ADDENDUM NO. 2

March 1, 2022

**TIMOTHY BALL ELEMENTARY SCHOOL ADDITIONS, RENOVATIONS,
AND RELATED WORK
Crown Point, IN 46307**

This Addendum forms a part of and modifies the Bidding Requirements, Contract Forms, Contract Conditions, the Specifications, and the Drawings dated February 7, 2022 by Gibraltar Design. Acknowledge receipt of the Addendum in the space provided on the Bid Form. Failure to do so may subject the Bidder to disqualification.

S-206

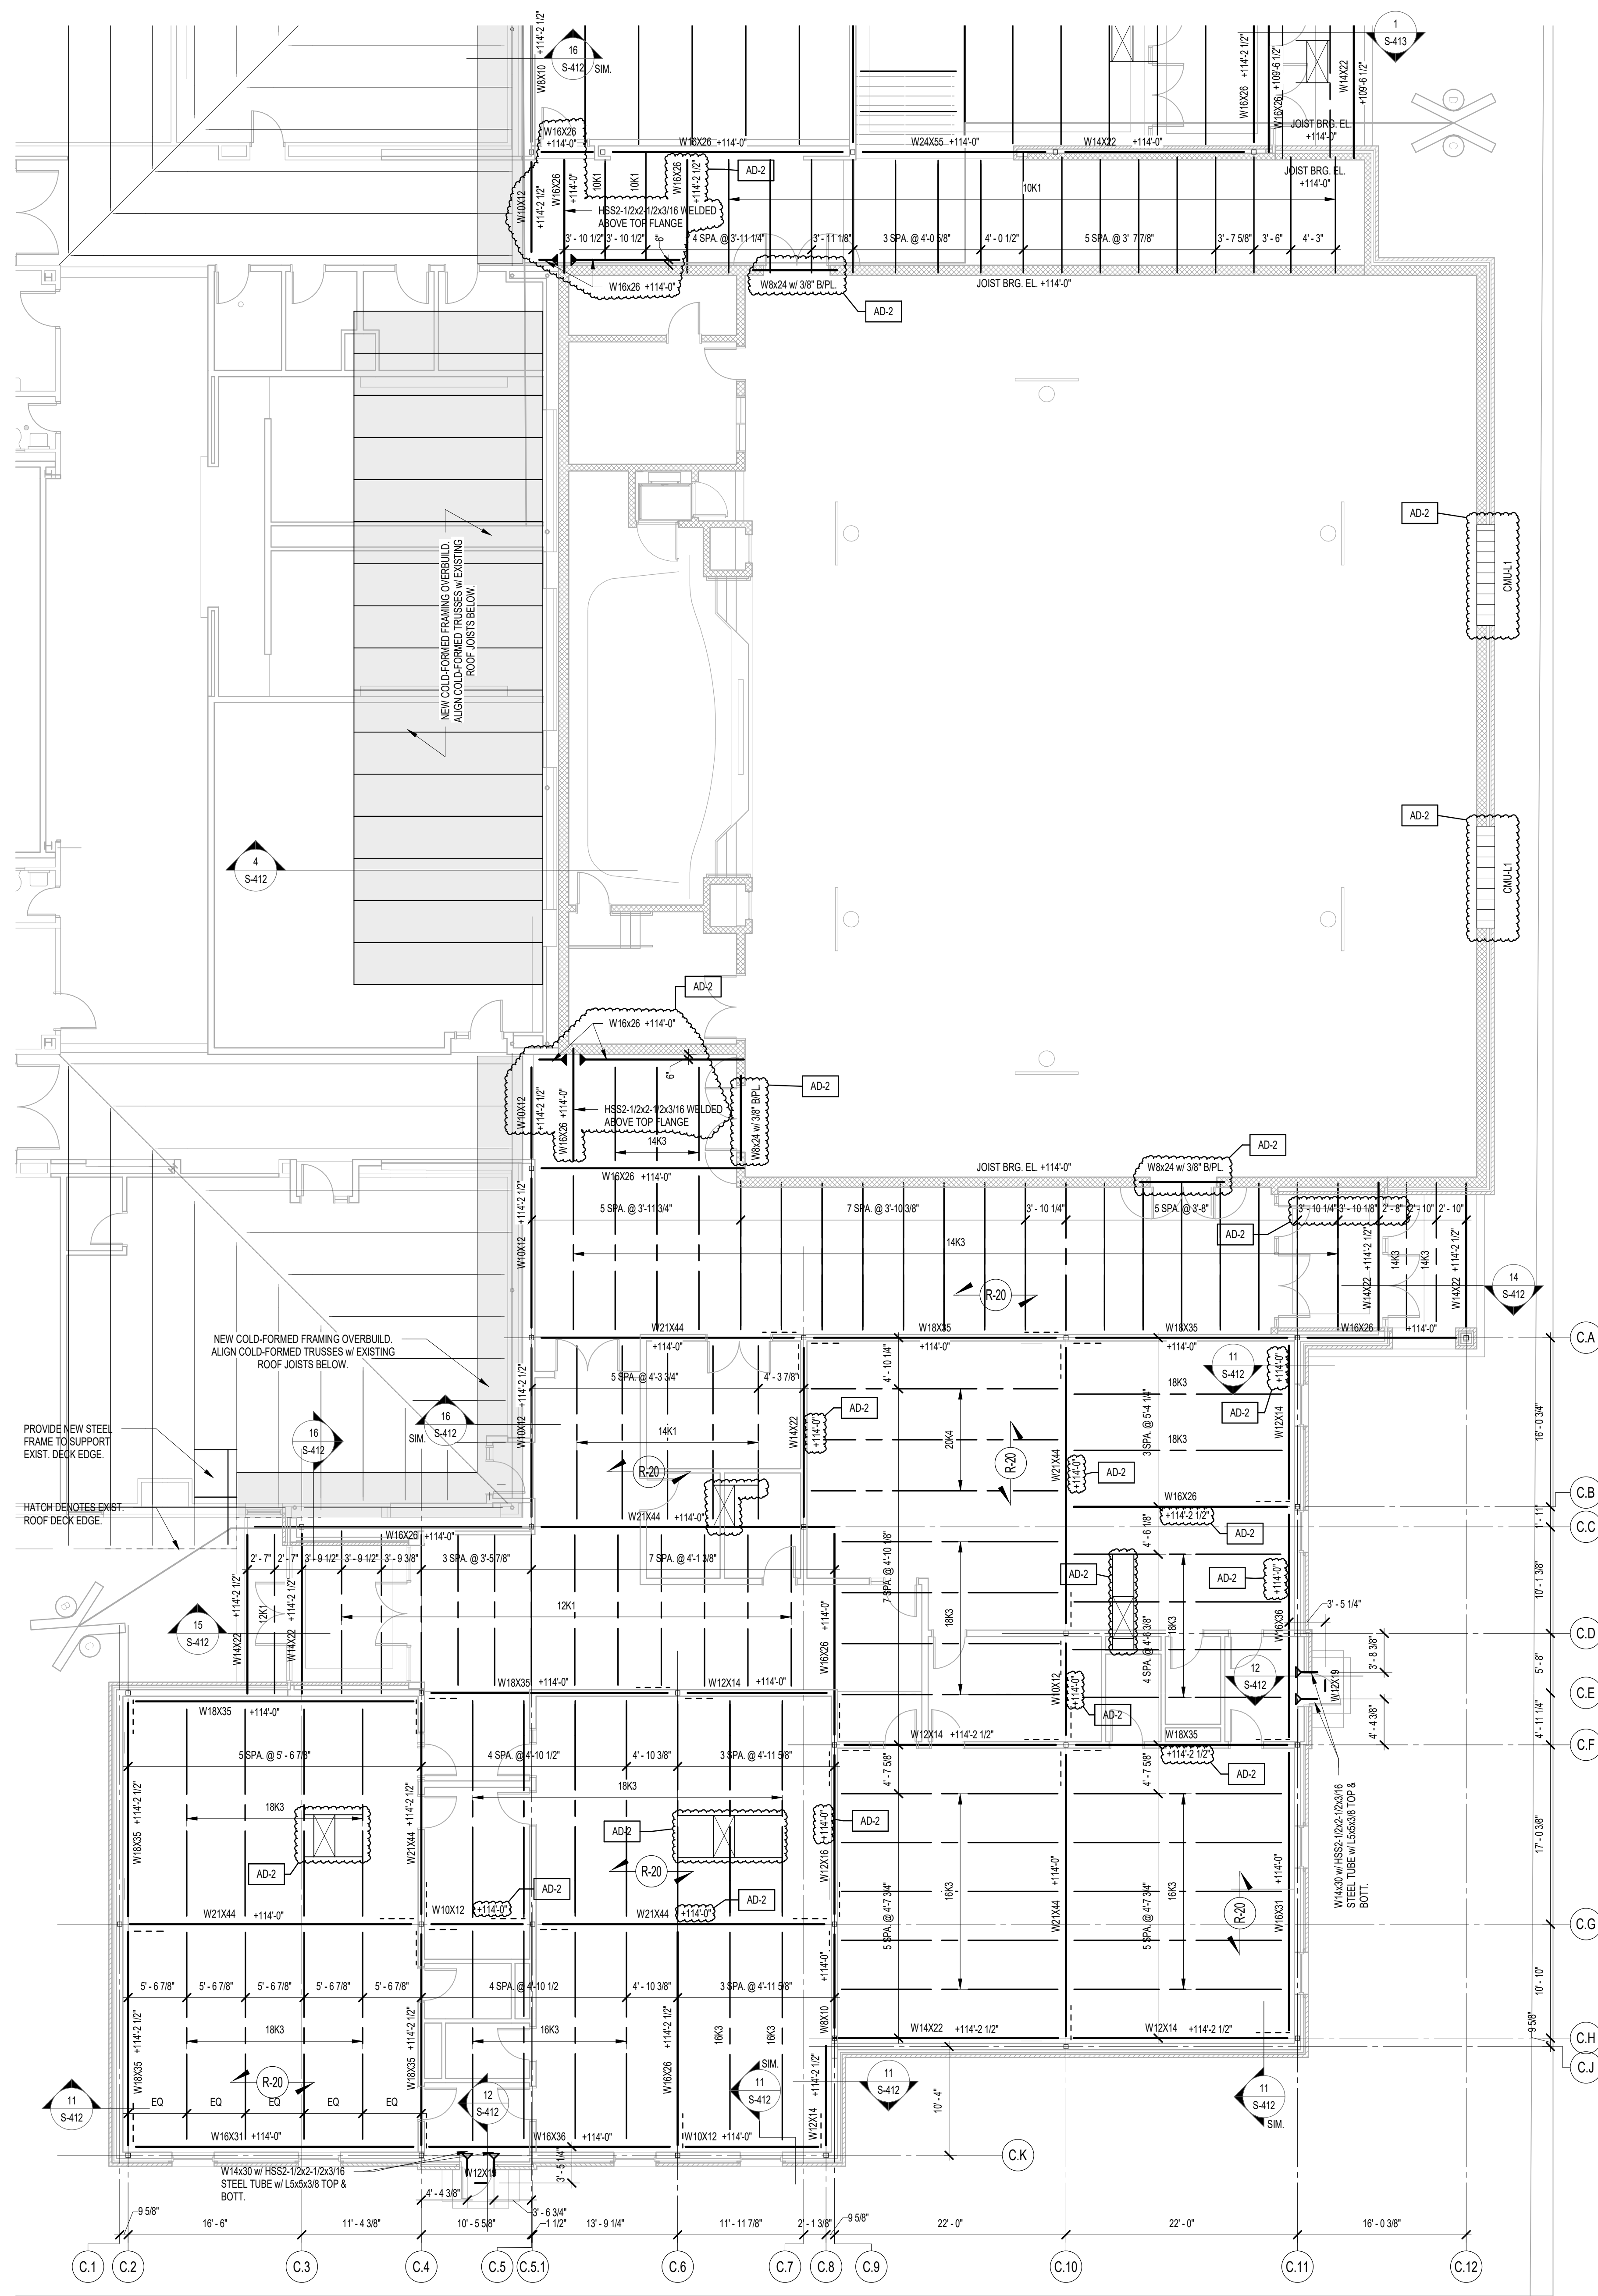
5. Sheet S-001, S-204, S-206, S-207, S-208, S-209, S-411, S-412, S-413

- A. Refer to revised, full size drawings, included in this Addendum, refer to bubbled revisions on each of the sheets.
